**ENGINEER'S DAILY REPORT**

**04-SF-80-13.2/13.9**  
**Contract No. 04-0120F4**  
**{SAS Superstructure}**

**RFI Response**

**Subject:** Panels, Circuit Breakers, Transformer at Tower Elev 89.85

RFI-1134-E-285C

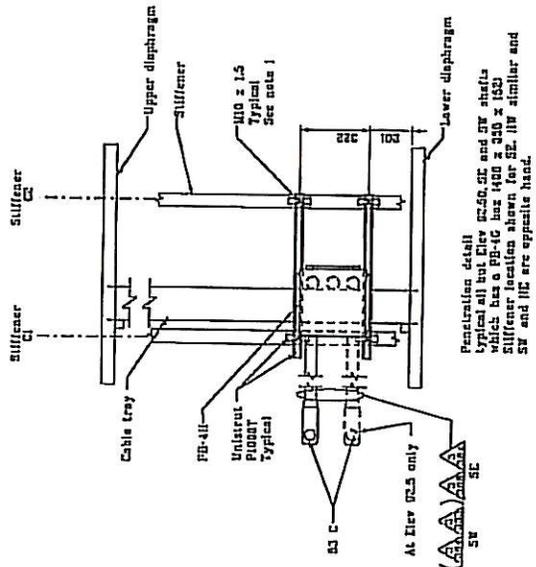
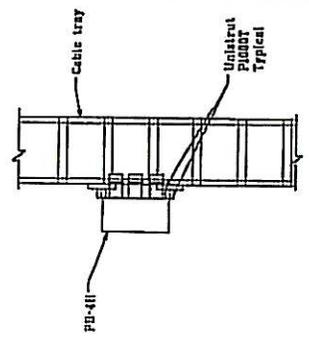
Subject RFI requested complete details for the relocation of panelboards, UP210-1A and UP210-1B, and associated circuit breakers and transformers from outside to inside the tower shafts at elevation 89.85, including but not limited to, mounting racks dimensionally located within the shafts, mounting penetrations, and attachments, conduit support, etc., and whether pullboxes 2G and 2H remain outdoor or relocated inside the tower shafts.

The answers to the RFI are shown on attached sketches.

Penetration detail typical all but Elev 12.5 and SW shafts which has a PB-4C box 1400 x 350 x 150. Stiffener location shown for SW and SC are opposite hand.
